IEEE802.3bt
LLDP adhoc

Meeting #5: Wednesday July 12, 2017
Revision 002

- **The purpose** of this ad-hoc is to resolve LLDP state machine related comments from D2.4 and related issues for PSE and PDs prior sponsor ballot for D3.0.

Annex A: Why we need $Y=A+B$ as currently in the spec? -2

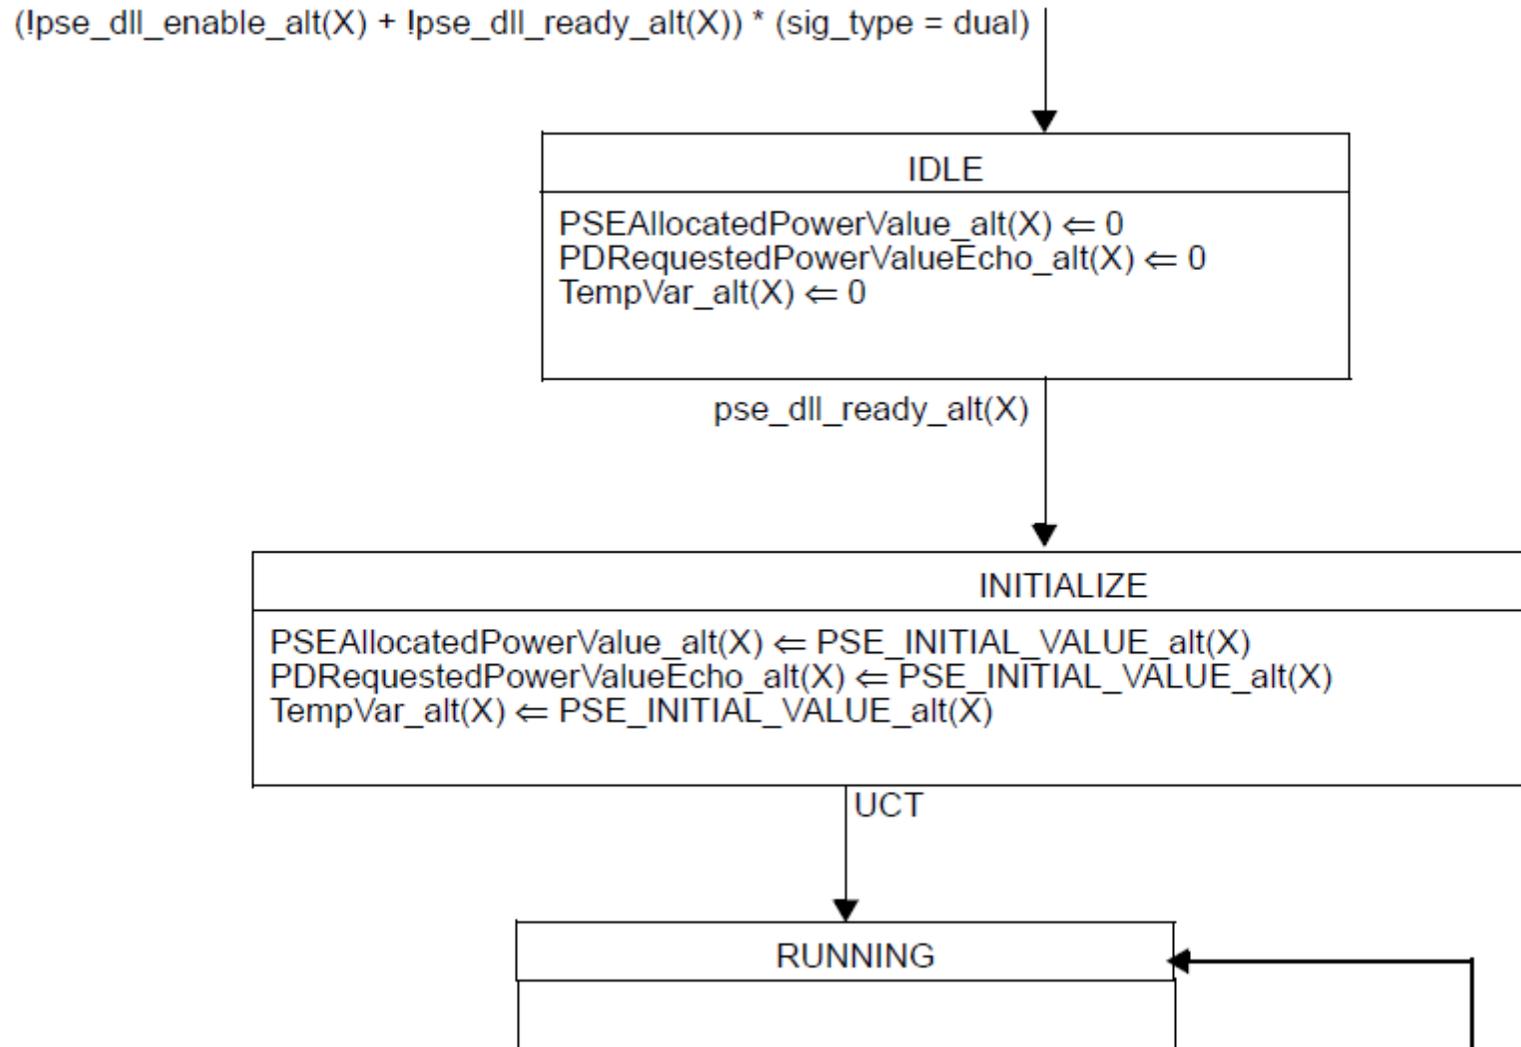
- Argument #3

High level power management care only for the total port power. The power management per pairset is kind of sublayer of the power management system. It is useful to pass the total power through the TLVs field. This is in general how current PSEs systems works.

Other alternative solution to this problem is to use the field “PSE max available power” which should be the total port power. We need to clarify in 79.3.2.6e that this value is applicable for PSE that supports single-signature and dual-signature.

Annex B: Comment #297 D2.4 (Page 75 line 12 in D2.5) - Figure 145-43

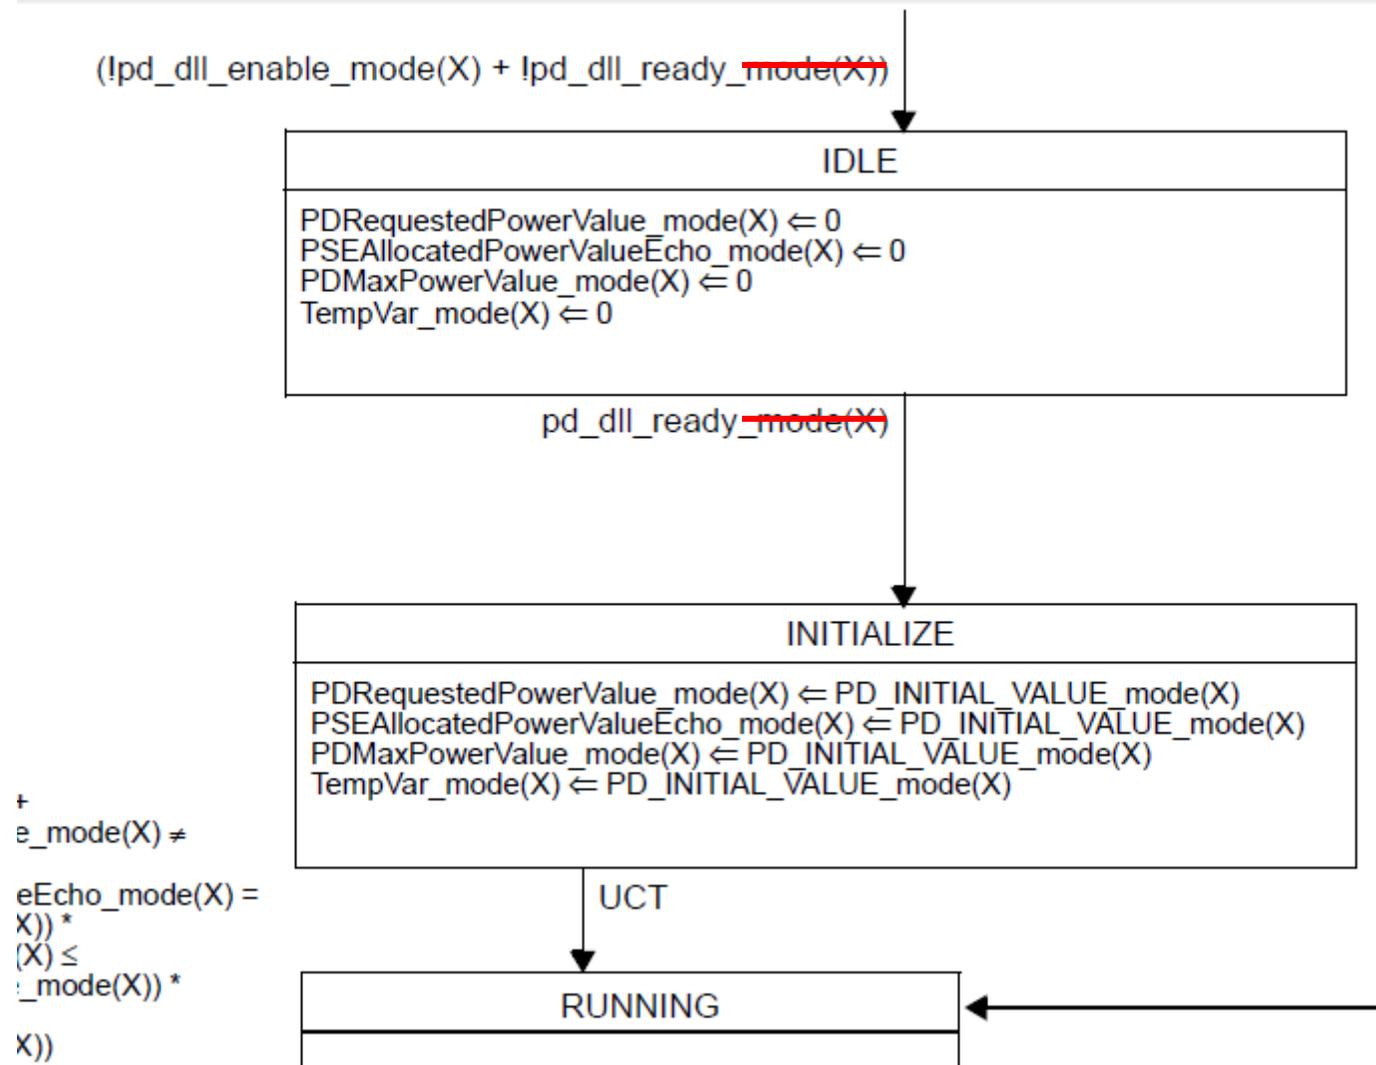
Annex B: Comment #297 D2.4 (Page 75 line 12 in D2.5) - Figure 145-44
 Proposal for a change marked in RED. Group is OK.

- Comment #297 D2.4 (D2.5 Page 78 line 46)

"If Mode (X) is non-active while the other mode is active, the inactive PD requested power value Mode (X) field value shall be set to 0."

- What is this trying to do ? The PD may wish to ask for power on an unpowered Mode...

Yair: What we are trying to do is:

- In Figure 145-44 and Figure 145-45 power control state diagrams when connected to dual-signature PD, we add in D2.3 an IDLE state in order to resolve non active Alternative(X) or no active mode(X) by setting the relevant variables to zero prior going to INITIALIZE state.
 - Figure 145-45: PSEAllocatedPowerValue_alt(X), PDRequestedPowerValueEcho_alt(X) and TempVar_alt(X)
 - Figure 145-46: PDRequestedPowerValue_mode(X), PSEAllocatedPowerValueEcho_mode(X), PDMaxPowerValue_mode(X) and TempVar_mode(X)

- $Y=A+B$ can be replaced to $Y=\text{mode}(X)$ in the PD and $Y=\text{Alt}(X)$ in the PSE. This is alternative solution to argument #1 in Annex A and will resolve the double information of A, B and $Y=A+B$ confusion argument raised by Lennart.

- We have the information of total available power in the field “PSE maximum available power” in 79.3.2.6e. This resolve argument #2 in Annex A.
- To resolve #297, Lennart suggests: In order to request power on the unpowered pairset, see proposed changes in the red text. In addition, the `pd_dll_ready_mode(X)` need to be changed to `pd_dll_ready` to allow progressing to the INITIALIZE state in case PD want power on the unpowered pairset. No changes required in the PSE portion.

- Yair it will work:
- The proposal is:
 - To change from `pd_dll_ready_mode(X)` to `pd_dll_ready` in the PD state machine.
 - To change “if this mode/Alt is inactive, set to value 0” to “if this Alt is inactive, set to value 0” i.e. keep this requirement only to PSE.

- Lennart response: The proposed response to this comment is to adopt:
 - To change from `pd_dll_ready_mode(X)` to `pd_dll_ready` in the PD state machine.
 - To change “if this mode/Alt is inactive, set to value 0” to “if this Alt is inactive, set to value 0” i.e. keep this requirement only to PSE.
- **Group to discuss.**
- **GROUP OPINION? Group is OK.**
 - The modifications proposed to the state machine in Figure 145-43?
 - To change from `pd_dll_ready_mode(X)` to `pd_dll_ready` in the PD state machine.
 - To change “if this mode/Alt is inactive, set to value 0” to “if this Alt is inactive, set to value 0” i.e. keep this requirement only to PSE.
